1130A-01A

# S E R V I C E N O T E

## 1130A Infiniimax Probe Amplifier 1.5GHz

**Possible fractured solder joint on input pin**

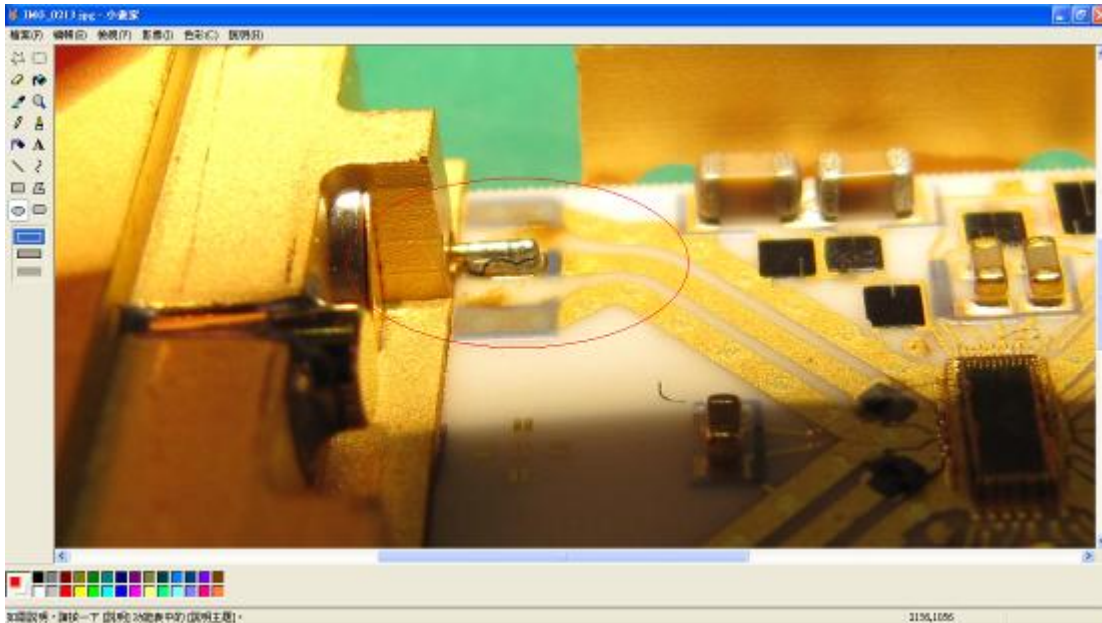
The above picture shows a fractured solder joint.

The above picture shows where the long pin of the probe amplifier actually got stuck in the female connector of the probe head. When the probe head was removed from the probe amp, part of the probe head female connector stuck to the probe amplifier pin and was pulled out.

5. If you determine that the solder joint is fractured, bent, broken, or probe head parts stuck to a probe pin, replace with a new 01130-68701 probe amplifier. Charge the replacement cost to factory warranty.

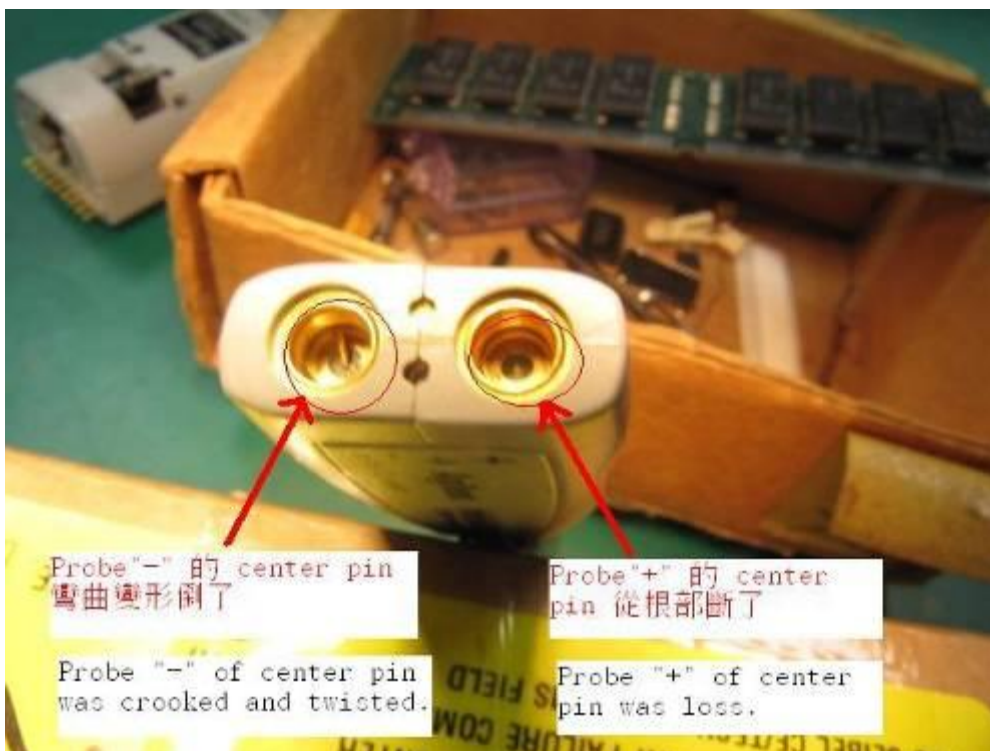
The above picture shows a bent male pin and a broken male pin. The longer male pin could cause the pin to bend or eventually break when connected to a probe head.

If you find the above mechanical defects, replace with a new 01130-68701 probe amplifier.
